NEW YORK STATE DEPARTMENT OF STATE
DIVISION OF CODE ENFORCEMENT AND ADMINISTRATION

APPLICATION FOR VARIANCE OR APPEAL

PETITION NO: 2016-0269
ROUTINE VARIANCE [ ]
BOARD VARIANCE [ ]
BOARD APPEAL [ ]
(FOR OFFICE USE ONLY)

The Rand Hall Fine Arts Library ("FAL") Project located in Ithaca, New York at Cornell University includes the continued and proposed use of the second and third floors of this existing building as a college library. Additions and modifications to the existing delineated second and third floors and the roof of the existing Rand Hall building are now proposed for the 2016 project. These modifications are the same as that submitted for Petition and Determination #2015-0432. Code drawings are included in this package as further information and use as Exhibit C.

1ST STORY  
CODE DRAWING

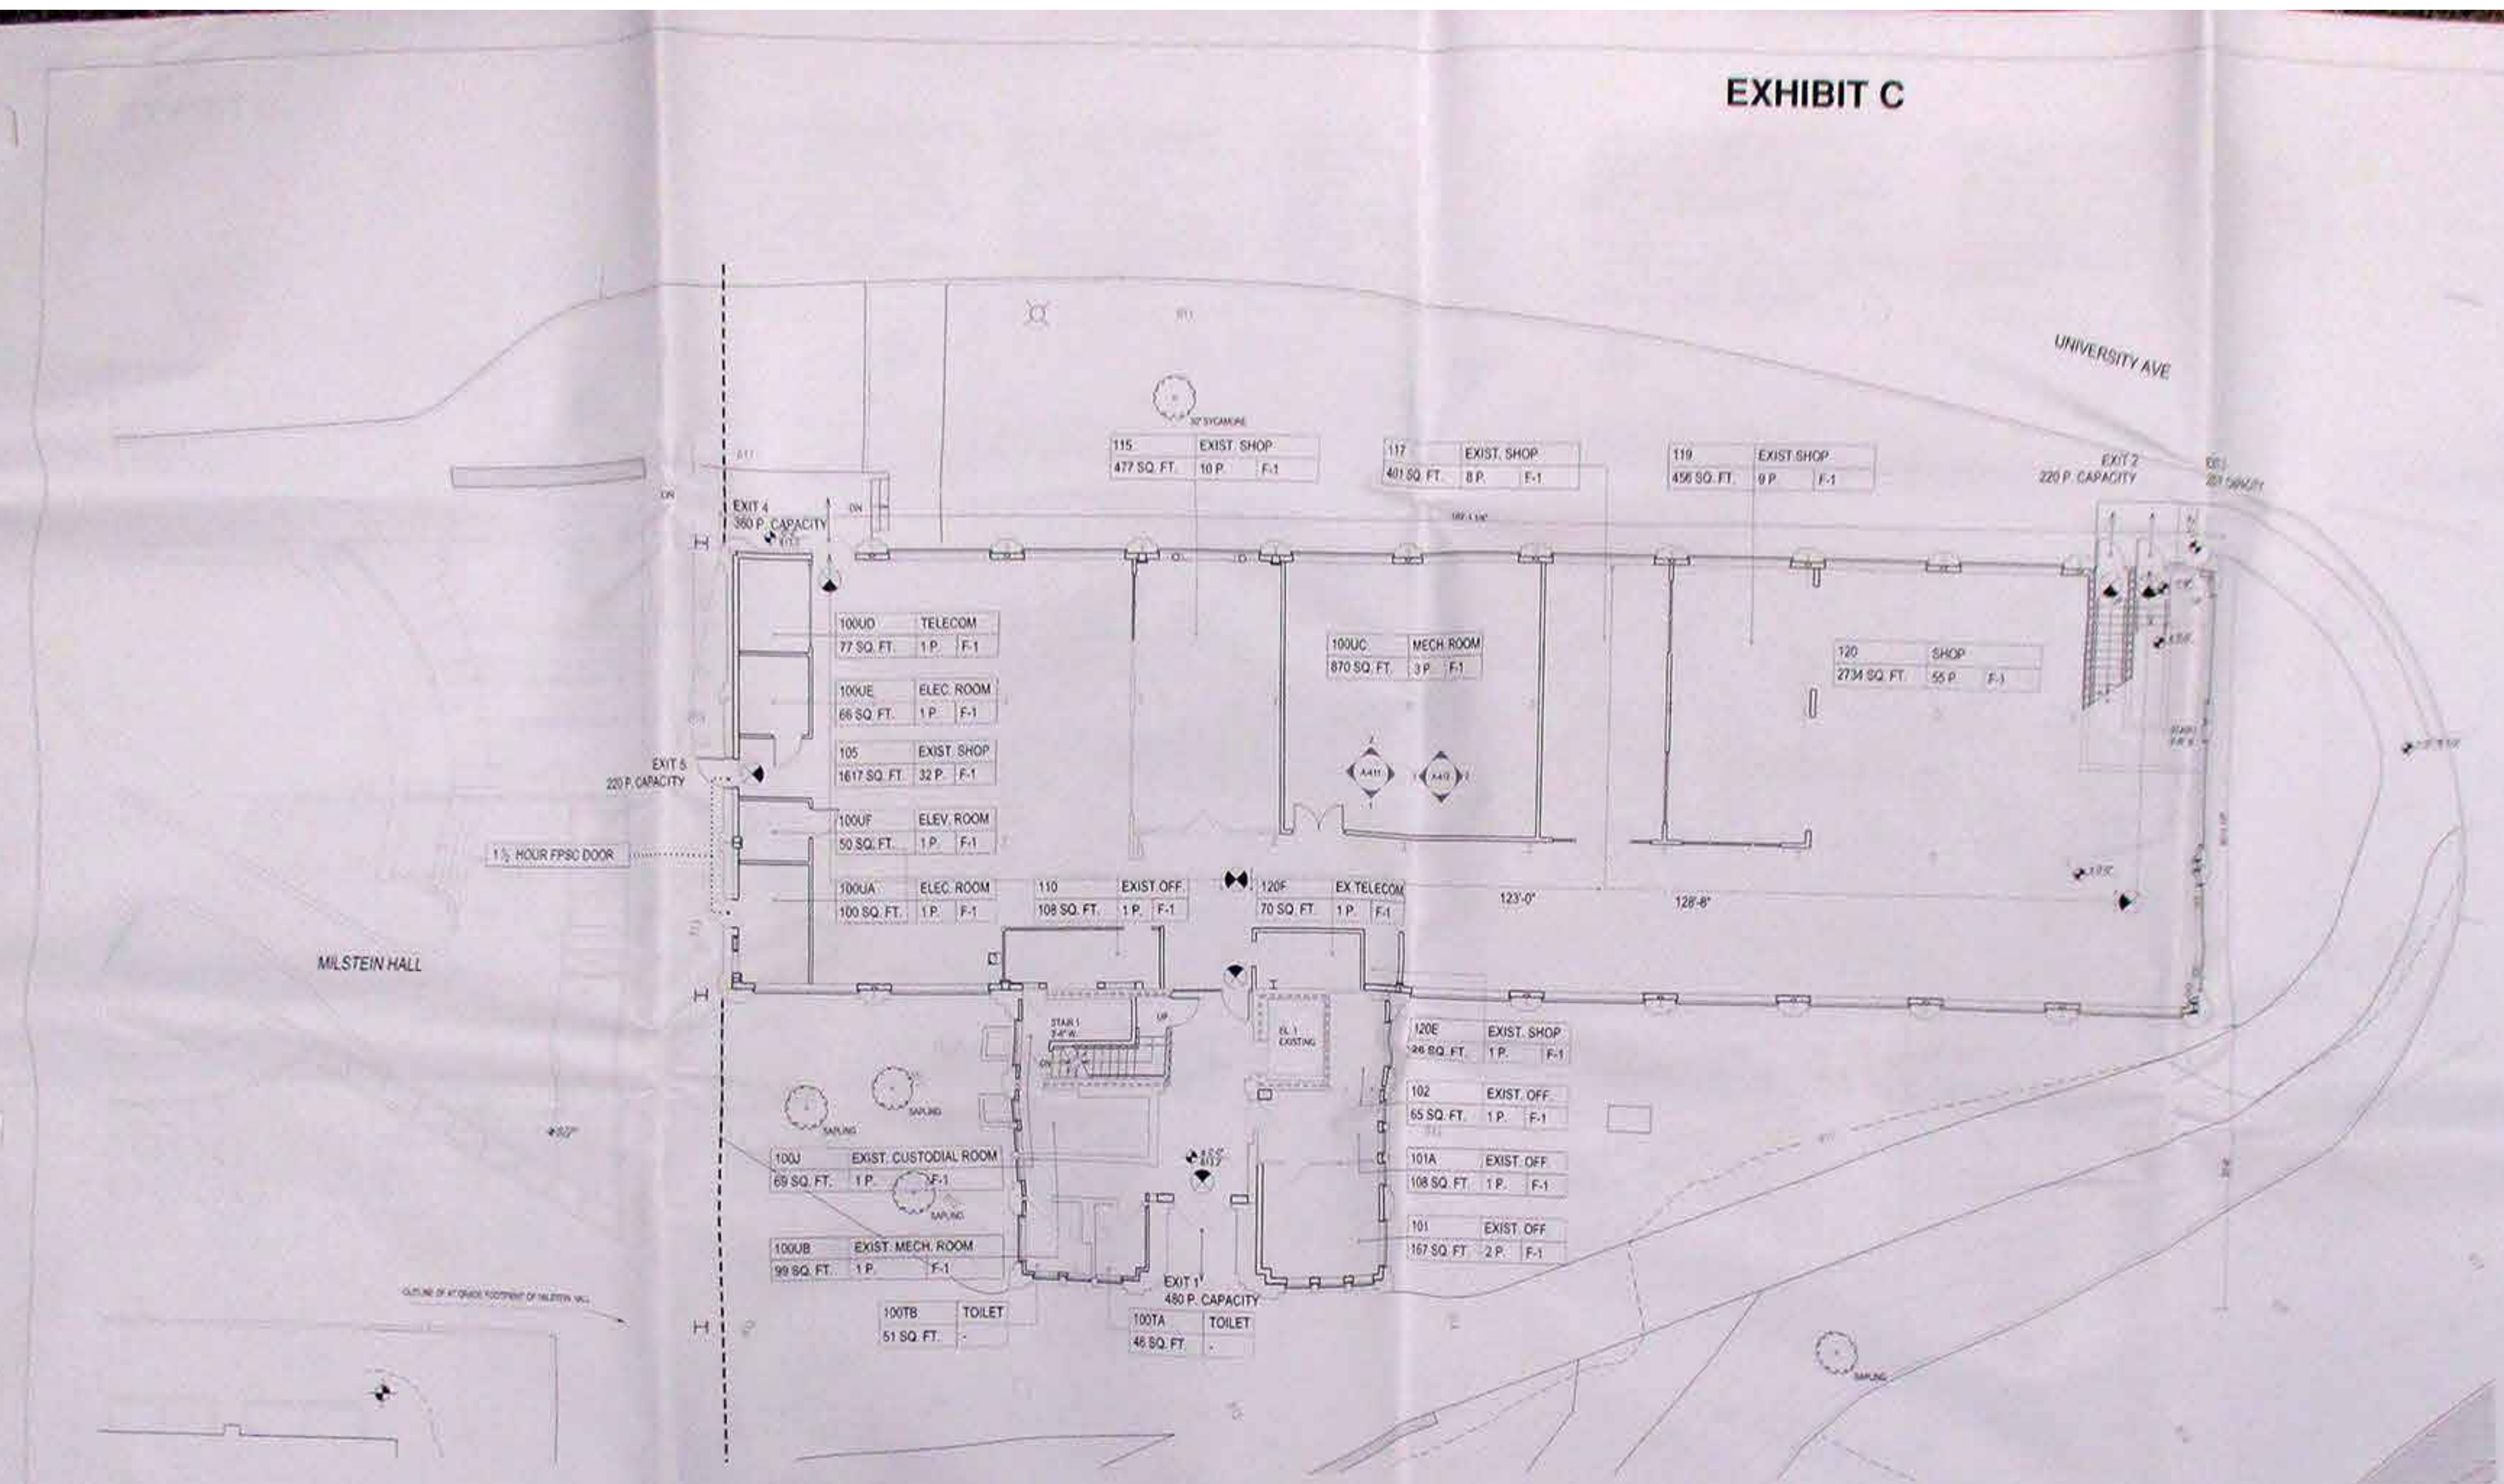
10 In Exhibit A, it was in the packet,  
11 just so you can get a perspective. I'll  
12 point to in Exhibit A, the first story  
13 code drawing, just so we can get  
14 oriented in the right directions here.  
15 When I'm speaking to the west, I'm  
16 looking at the left-hand side of this  
17 drawing, and that's connected to  
18 Milstein Hall, which is an exterior  
19 wall, to which is the discussion of the  
20 previous determination. The other three  
21 sides of the building, the north, top of  
22 the sheet in Exhibit C, the east is on  
23 the right side of the drawing, and the  
24 south is on the bottom side of Exhibit  
25 C, first story code drawing.

4TH STORY MEZZANINE  
CODE DRAWING

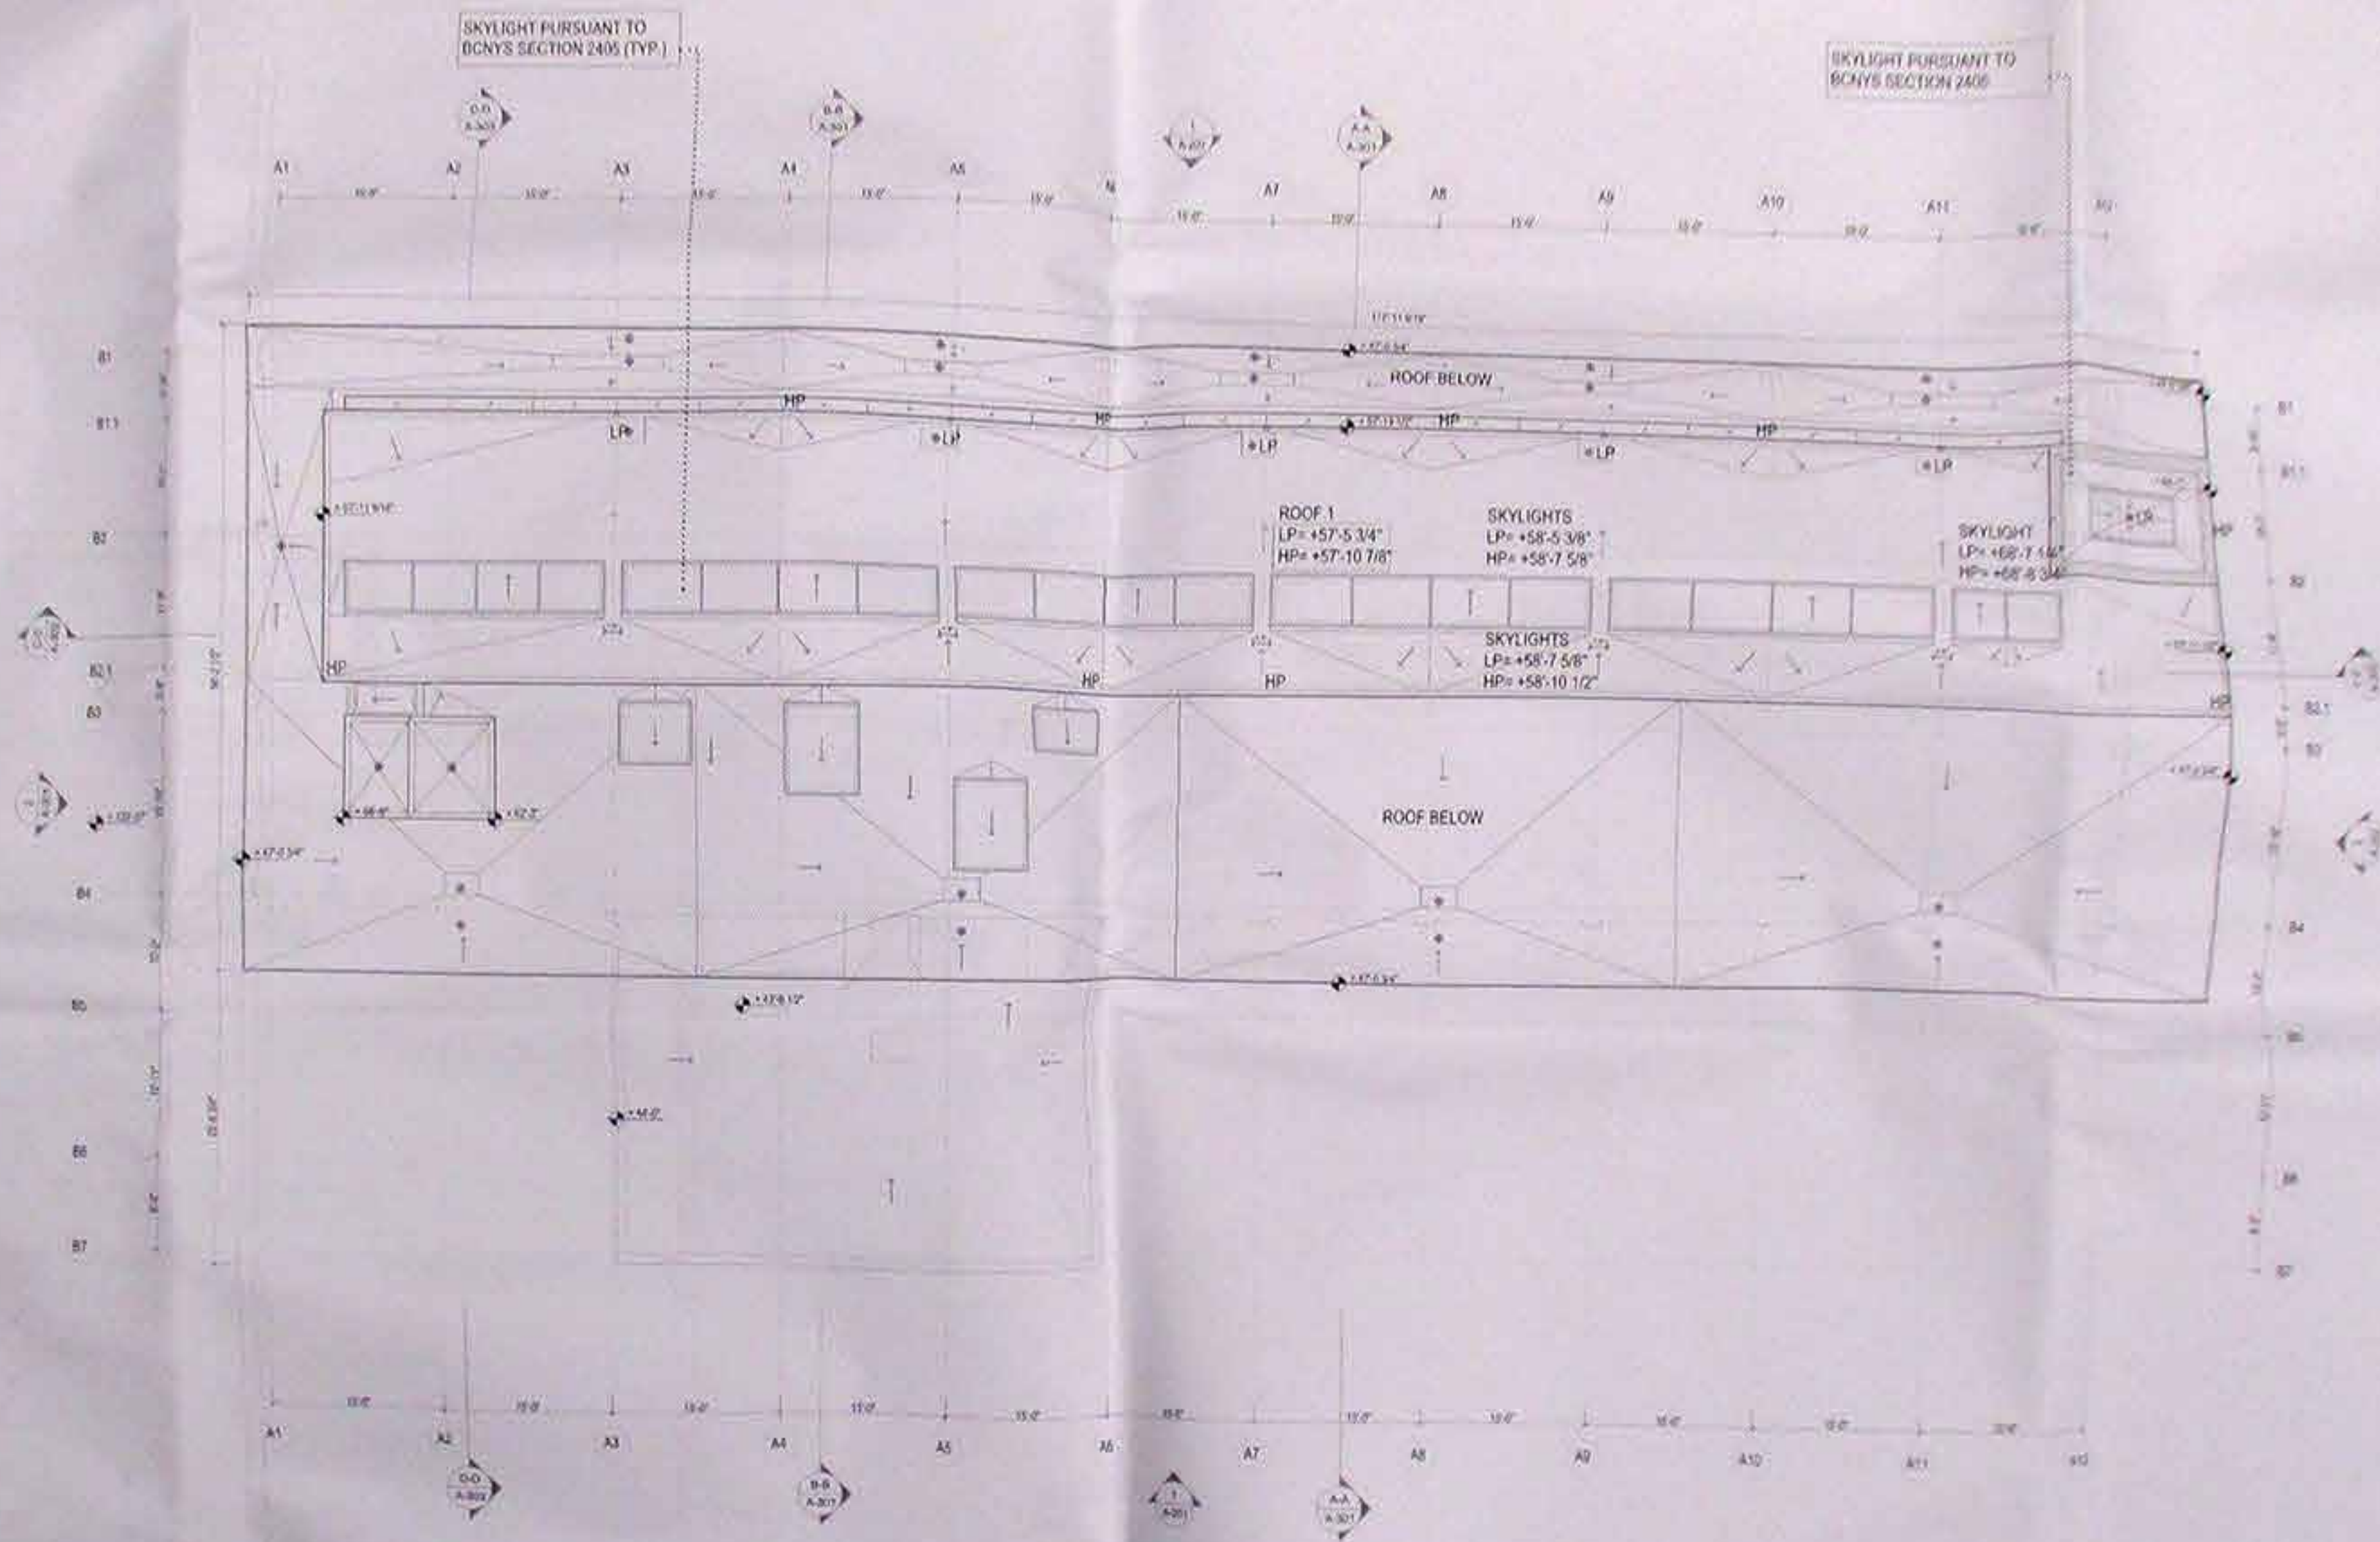
I'll go on to the next request. Is the use of a combination of two elevators to go down to grade, with an ambulance stretcher or one large elevator from one and two, and then using the stairs from upper levels. That will be looking at Exhibit C, Section BB code drawing, which shows a section of the building. The top level being a mezzanine 4. The next floor down and shown in the green is floor 4, the light blue is floor 3 and then the blue is floor 2.
